5440 WADE PARK BLVD, SUITE 102 WWW.BGEINC.COM NC LICENSE #C-4397 ©2023	DESIGNED BY:				
	DRAWN BY:				
	REVIEWED BY:		DF		
			DF/JWM	10/02/2023	PER TOWN OF ROLESVILLE COMMENT
				08/01/2023	PER TOWN OF ROLESVILLE COMMENT
		REV	06/01/2023	INITIAL SUBMITTAL

PARKER RIDGE
82 SCHOOL STREET
ROLESVILLE / NORTH CAROLINA / 27571

CARVED STREET CT PLAN
AND PROFILE

GW4 GREENWAY PLAN AND
PROFILE (1 OF 2)

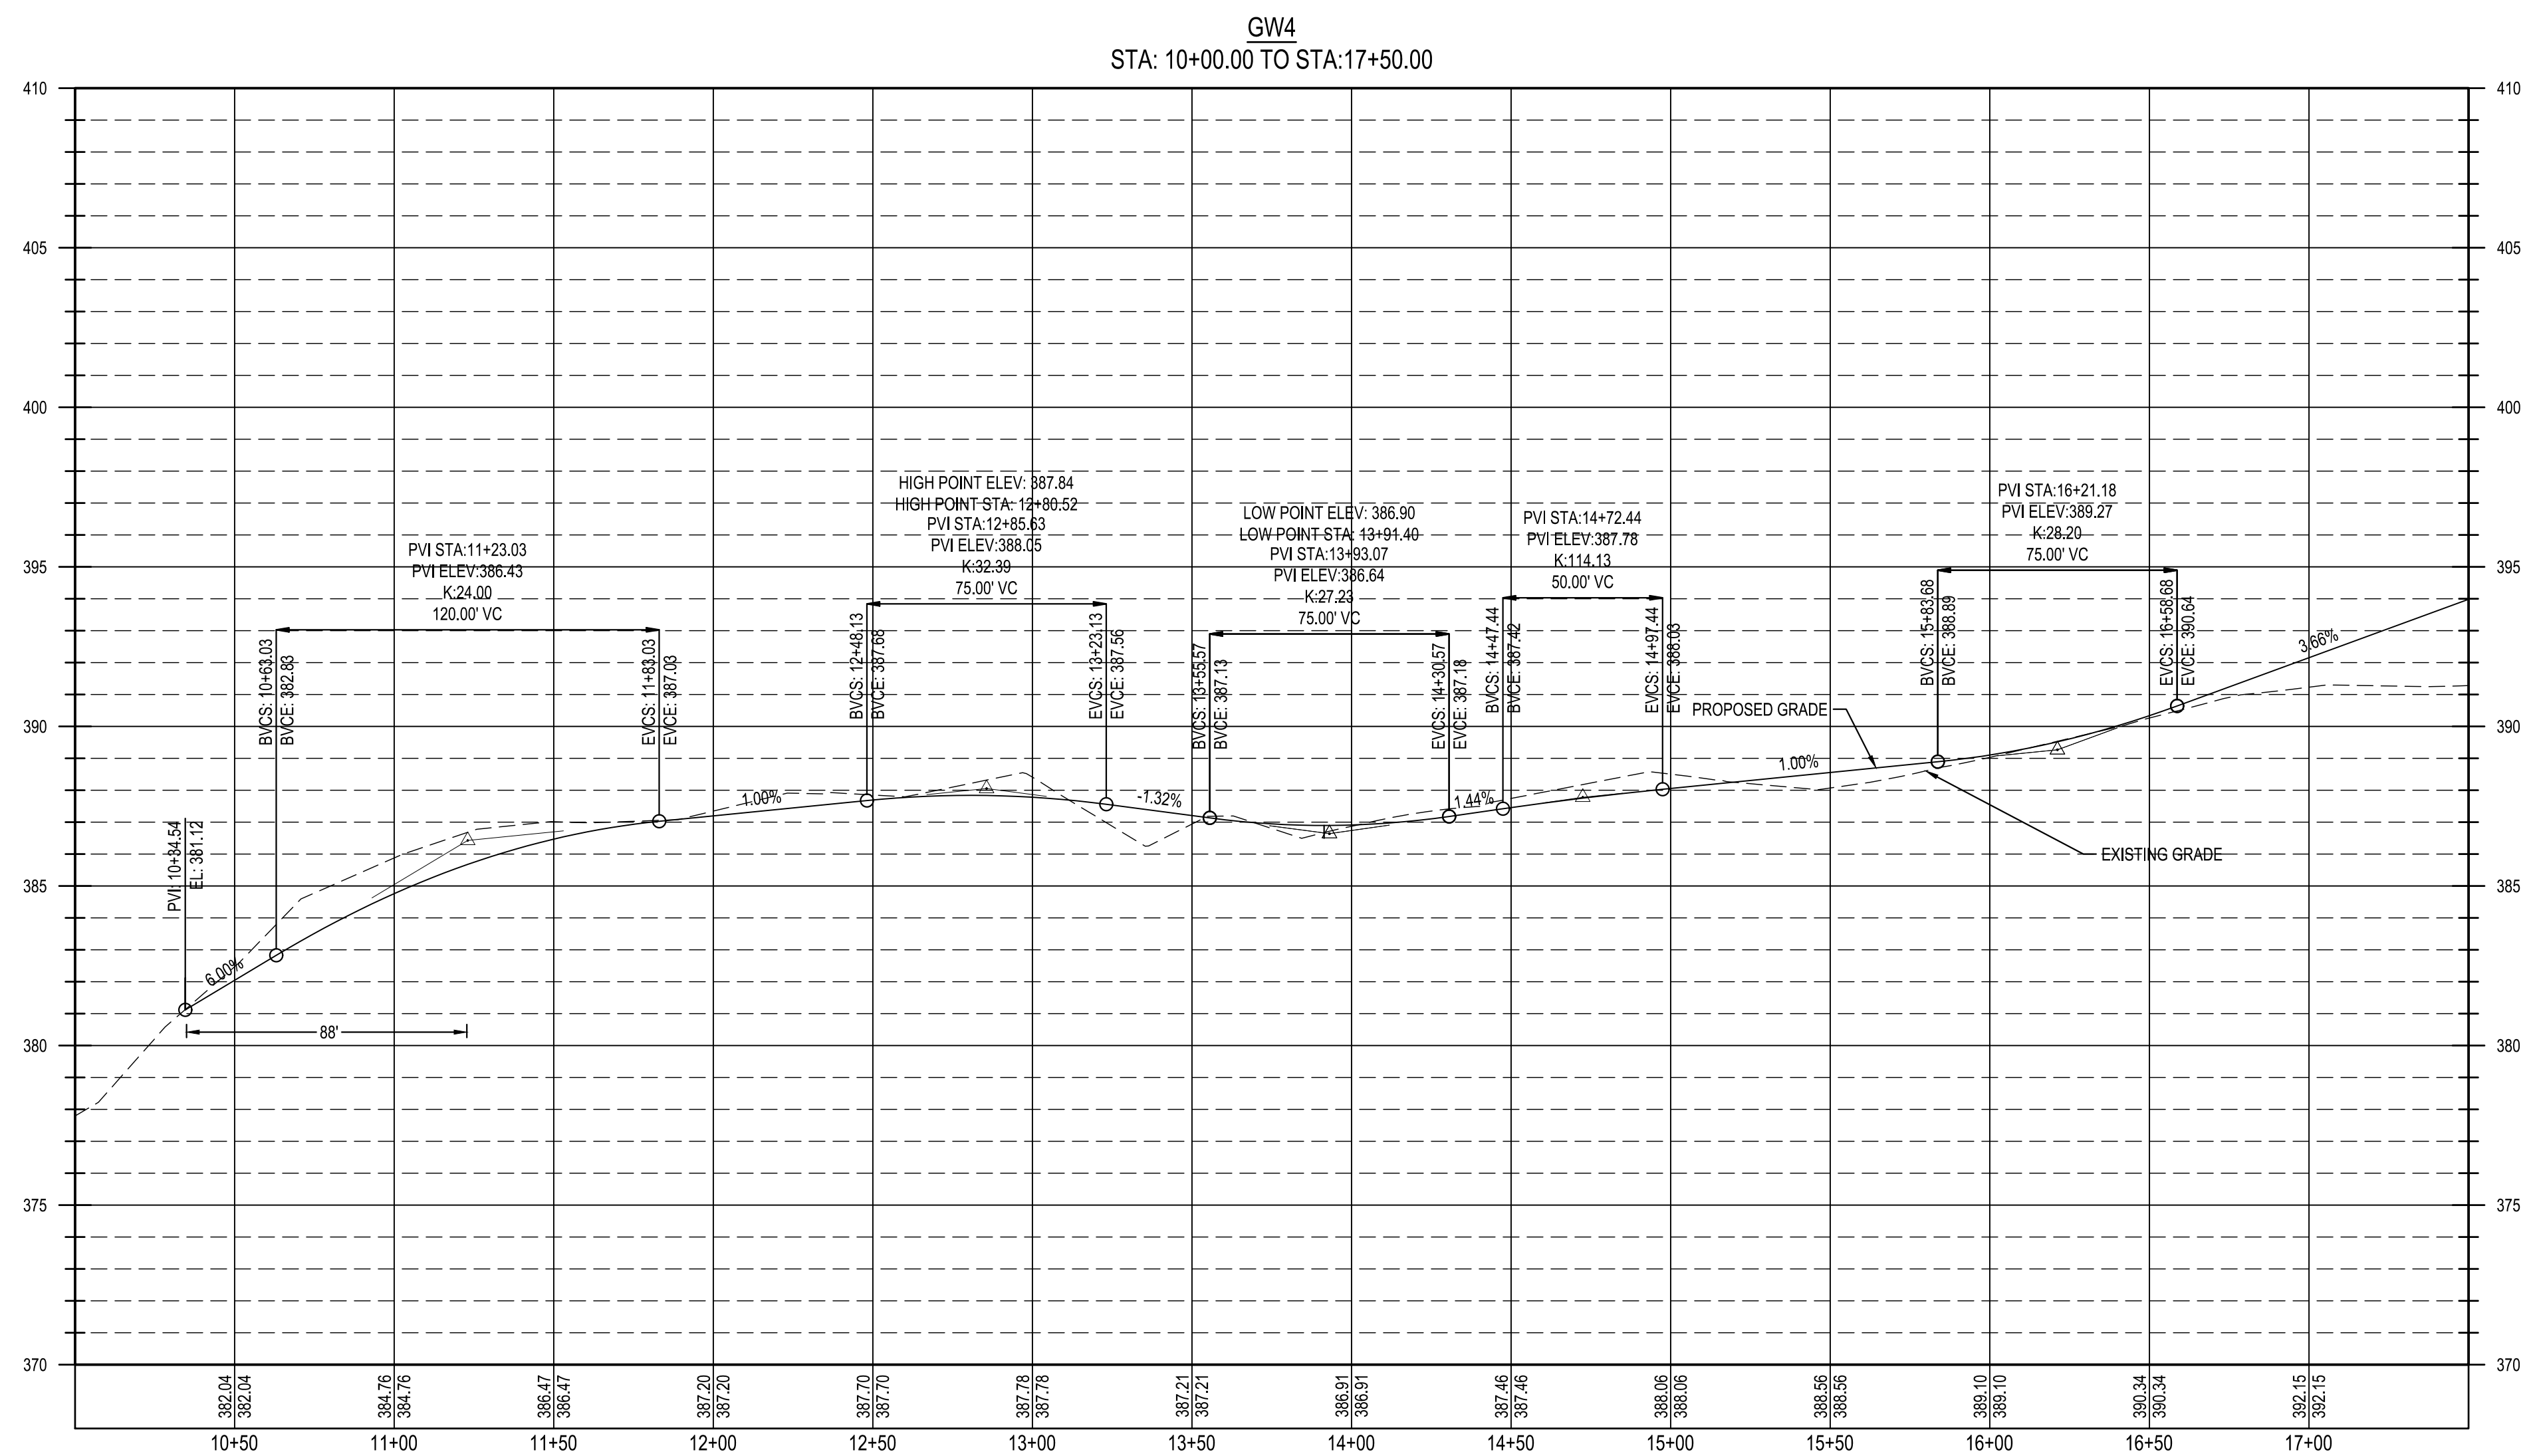
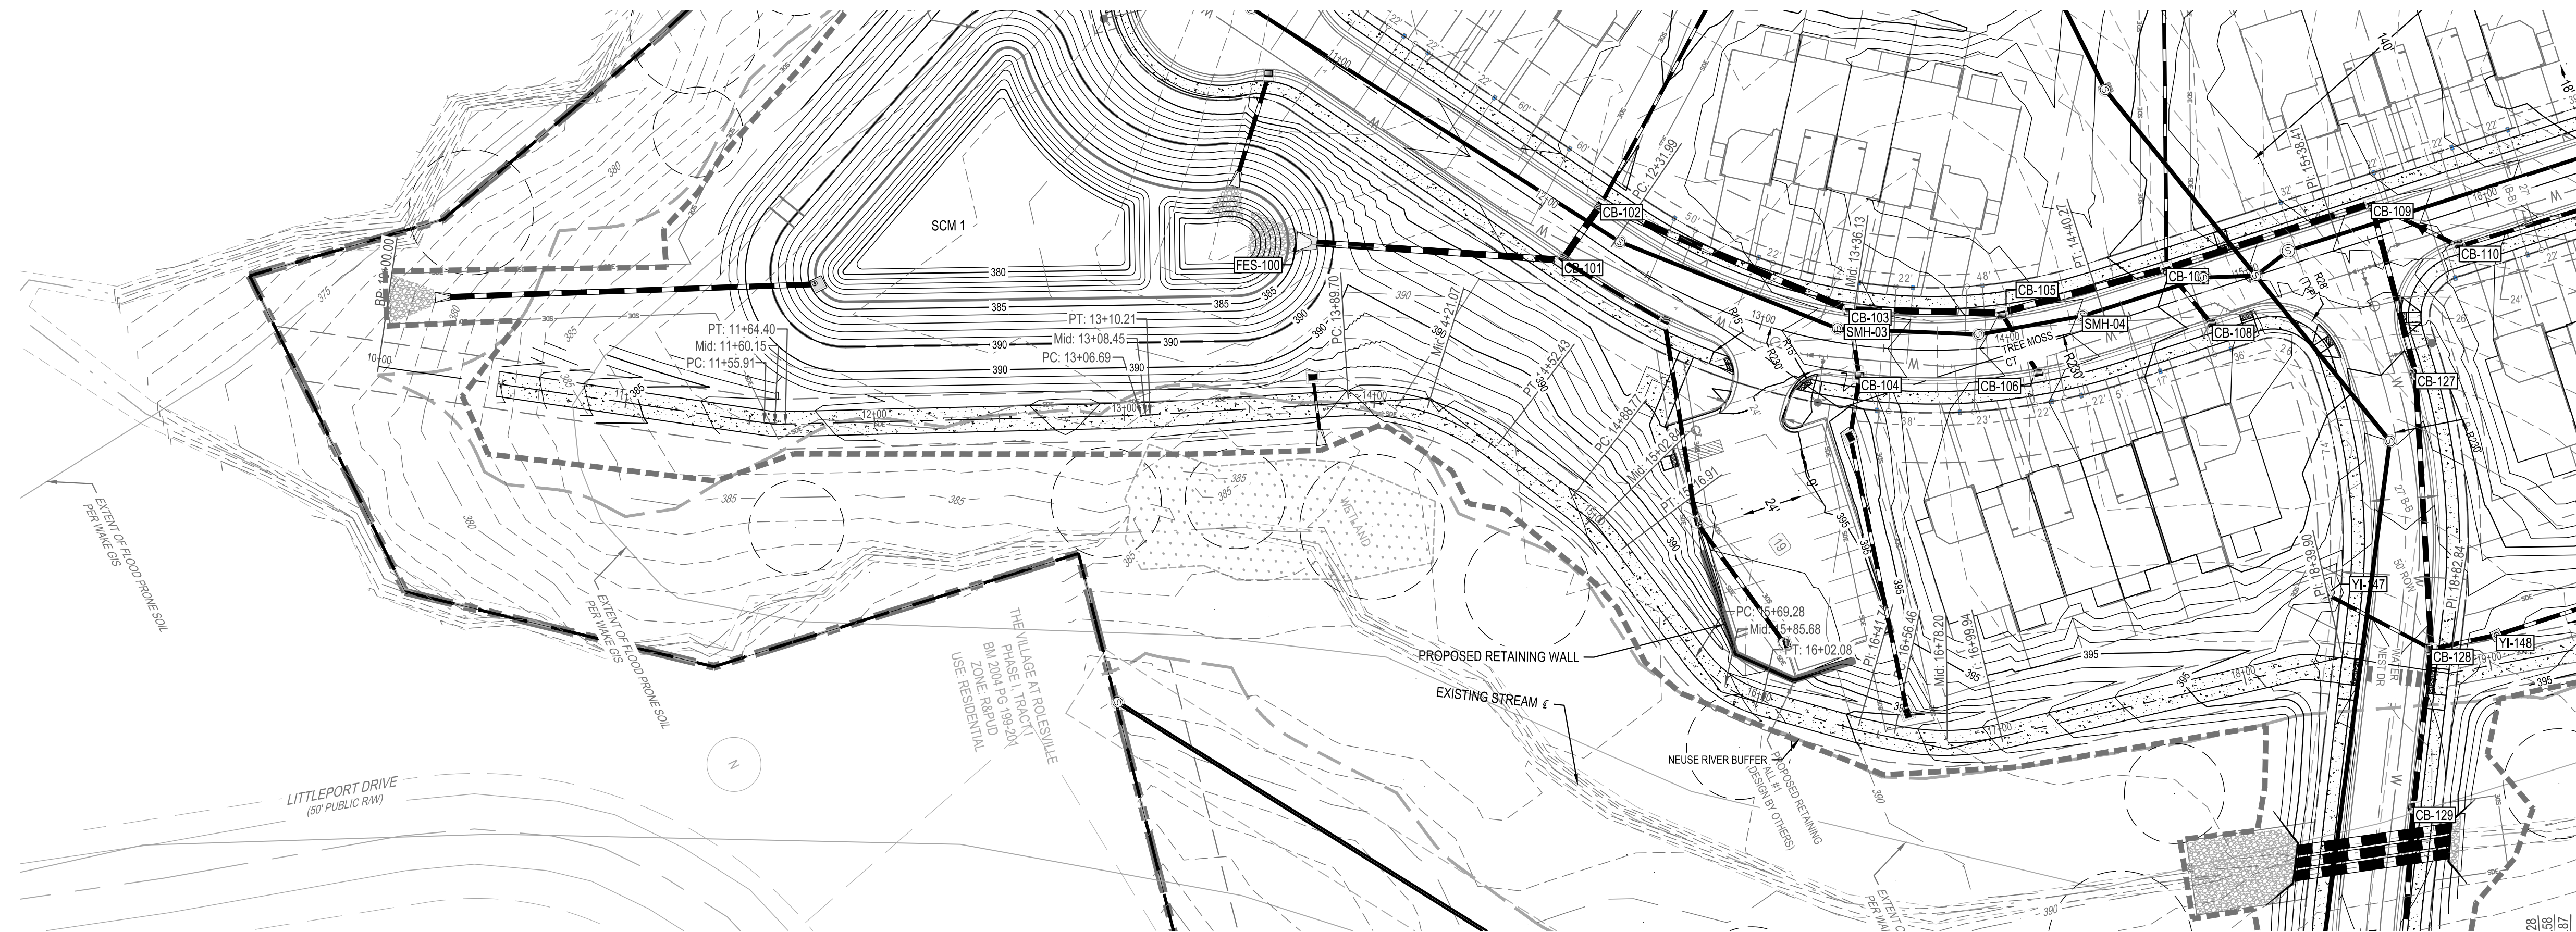
#102- Make sure dimensions are in the correct locations and it is clear what is being dimensions. Some dimensions don't seem to line up with top/bottom of pipes. If crossings do not meet minimum requirements, the design will need to be adjusted. Minimum separation requirements should be shown at all pipe crossings. This comment applies to all profile sheets.
